Re: Rural 'B' Area within Lot 467 - Objection submission COM/2019/81

Attachment A1 - Plan C1495:00:13B - Close up of Rural 'B' (or 'This portion of Extractive Zone To be rezoned to Rural 'B')

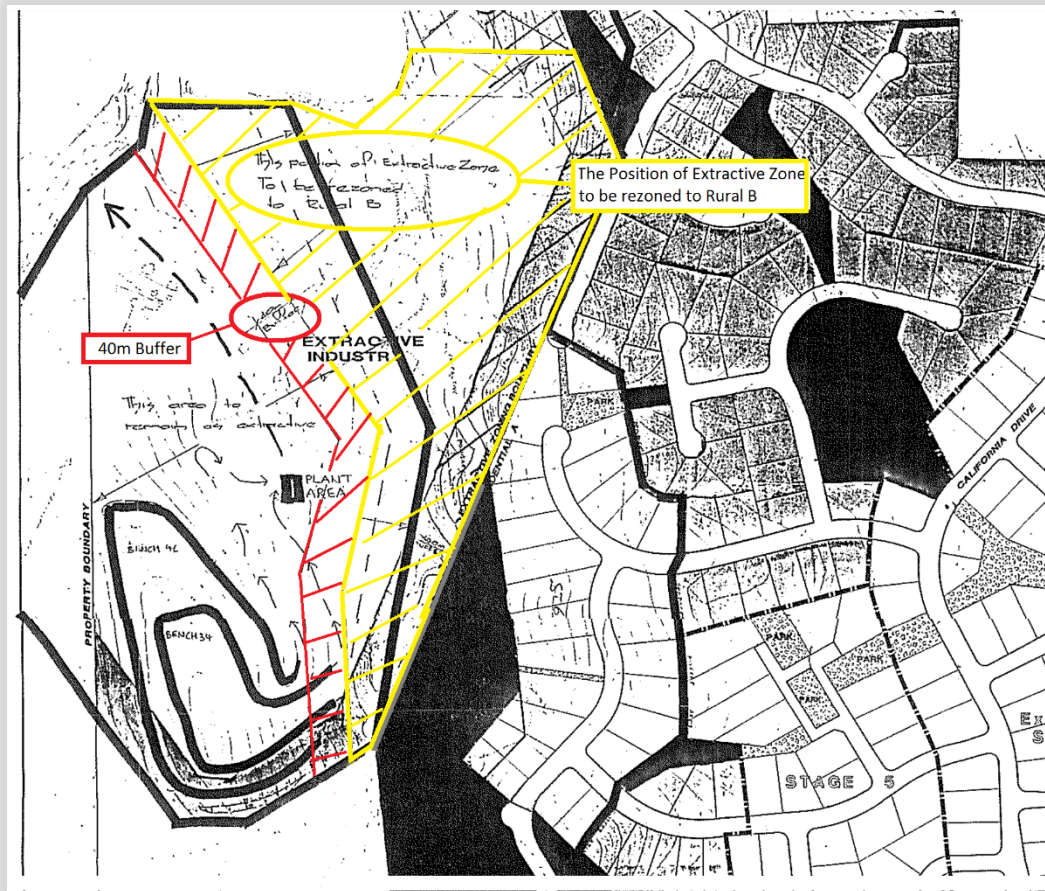
I am very concerned that an email you have sent suggests that the Rural 'B' or 'This portion of Extractive Zone To be rezoned to Rural 'B' (reproduced in Attachment A1 and a close up in Attachment A2) is irrelevant after the 17<sup>th</sup> February 2022.

It is noted virtually all references to the Rural 'B' area were seemingly omitted from the development application (e.g. the omission of Plan C1495:00:13B, Attachment A1) or, it would appear, designed to mislead (as per the seemingly culpable moving of the Rural 'B' area to Lot 468 as shown in Attachment B1). This, I believe, is the applicant realising that their actions in this matter are highly dubious. I further note SARA were unaware of these current approval limitations in this area and were therefore, I believe, misled at the time of SARA referral and subsequent approval. I do hope you will ensure this situation is rectified for the SARA re-referral?

I must insist the rezoning of this area is progressed immediately to ensure adequate separation buffer is maintained as is the clear intent of the Alberrshire Council at the quarry's inception and was agreed by the applicant. Please action, what I see as a clear breach of contract, on my behalf, internally within Council as appropriate. Thank you.
